Access Compliance Report

Public Rights-of-Way

(Pedestrian Signals)

Intersection ID: N/A	Main Street:	Cross Street: N/A	Location: N/A
ADA ID: 6733C99F21FB	Signal Type: One Push Button-Non APS	Overall Compliance: No	Severity Score: BTN 1: N/A BTN 2: N/A No BTN: N/A
Codes/Mitigation Info/Possible Solution		Field Measurements/Component Compliance

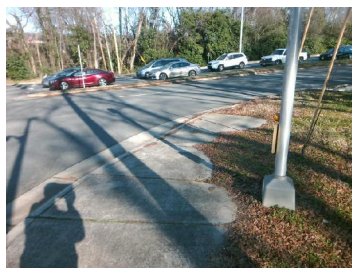
Possible Solutions: Replace Signal Push Button With APS Button on New Post. Remove & Relocate Sign.

PROW/ADA: TMUTCD 4e.08, R406.2, R404.7.3
